Please find below the response to the review formulated for the CDM project “Jidong Cement Panshi Co., Ltd. 15 MW Cement Waste heat Recovery Project “ with the registration number 2780. In case you have any further inquiries please let us know as we kindly assist you.

## **Response to the CDM Executive Board**

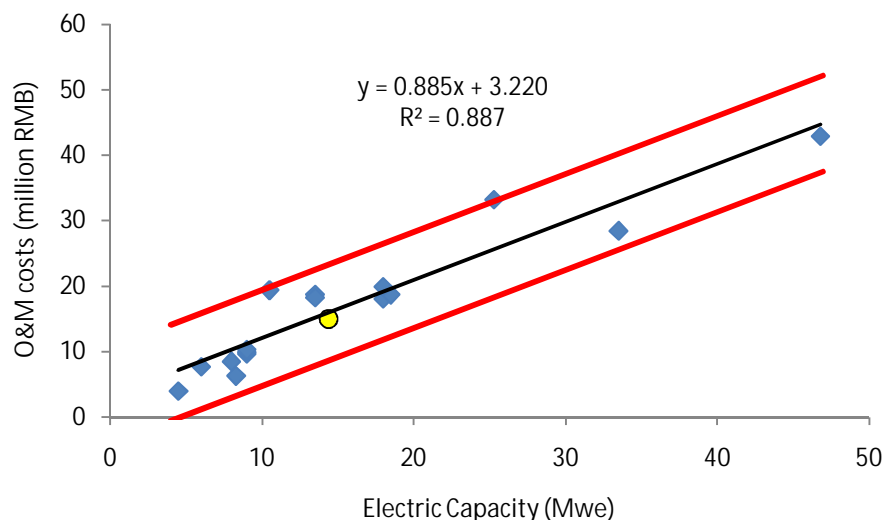
The DOE shall further substantiate the suitability of input values to the investment analysis in line with the paragraph 111 (c) of VVM, in particular: (a) different annual operating days considered for two cement lines; (b) turbine and generator efficiencies; and (c) O&M costs.

***2. The DOE shall further substantiate the suitability of input values to the investment analysis in line with the paragraph 111 (c) of VVM, in particular: (a) different annual operating days considered for two cement lines; (b) turbine and generator efficiencies; and (c) O&M costs.***

As mentioned above, we have compared the annual O&M cost of the proposed project activity in the FSR (i.e 14,955,900RMB) to similar registered projects listed in Annex 1. The projects were plotted in a scatter graph with their O&M costs in RMB on the (y)-axis and the Installed Capacity in MW on the (x)-axis. These projects are the basis of the regression analysis. The installed capacity was predicted based on the average mean of the O&M cost per installed capacity and the standard deviation. The regression formula has been defined as:

$$\text{O\&M (million RMB)} = 0.885 * \text{Cap (MW)} + 3.220$$

The correlation coefficient ( $R^2$ ) of 0.887 indicates there is a good correlation between the O&M costs and the electric capacity. The standard error (SE) of 3.675 has been calculated based on the difference between the predicted (theoretical) values and the O&M costs listed in the PDDs.

The figure below depicts a regression analysis assuming a linear relationship between the Installed Capacity in MW and the O&M costs in RMB for similar cement WHR projects. The proposed project activity (yellow dot) is within -2 standard errors (indicated in red line) below the black trend line, which means that the O&M costs of the project activity can be considered reasonable compared to all other similar projects. Hence, we can conclude our “crosscheck” in accordance paragraph 111(c) of the VVM, concludes that an IRR calculation based on the O&M costs listed in the FSR reasonable.
